70-1100

Docket No. 70-1100
License No. SNM-1067

Subject: Organization Update Information

COMBUSTION ENGINEERING, INC.
WINDSOR NUCLEAR FUEL MANUFACTURING FACILITY
LIST OF AFFECTED PAGES

FIGURE 3.1.1
WINDSOR NUCLEAR FUEL MANUFACTURING FACILITY
AND
PRODUCT DEVELOPMENT
ORGANIZATION STRUCTURE

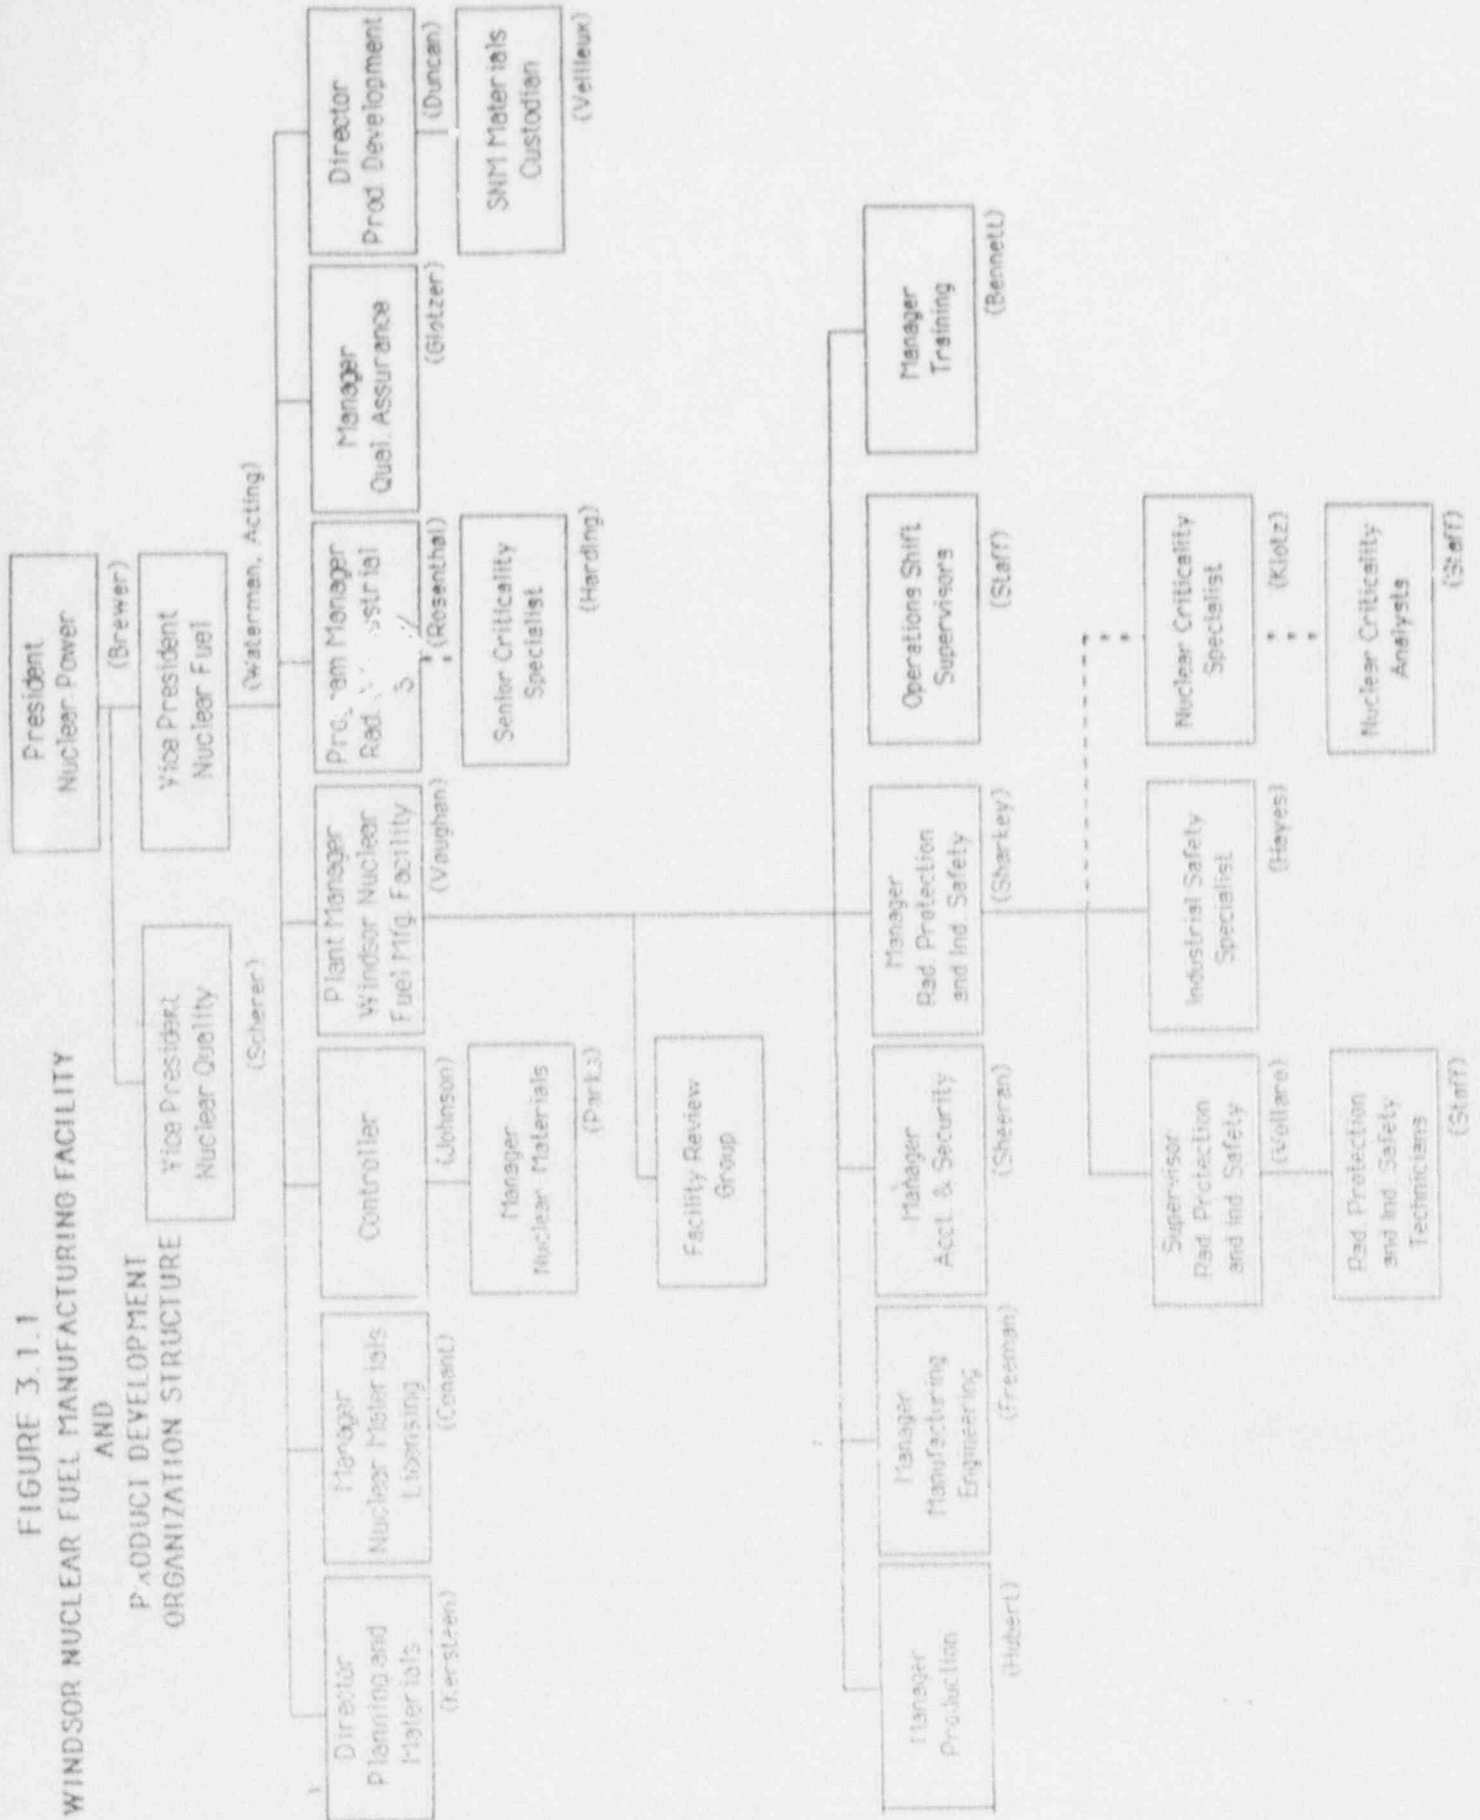
Functions of key positions important to safety, specifics on education and experience required for key positions important to safety, operating procedures, and training are described in Part I, Chapter 2.0 - Organization and Administration. The Windsor Nuclear Fuel Manufacturing facility and Product Development organization structure is depicted in Figure 3.1.1.
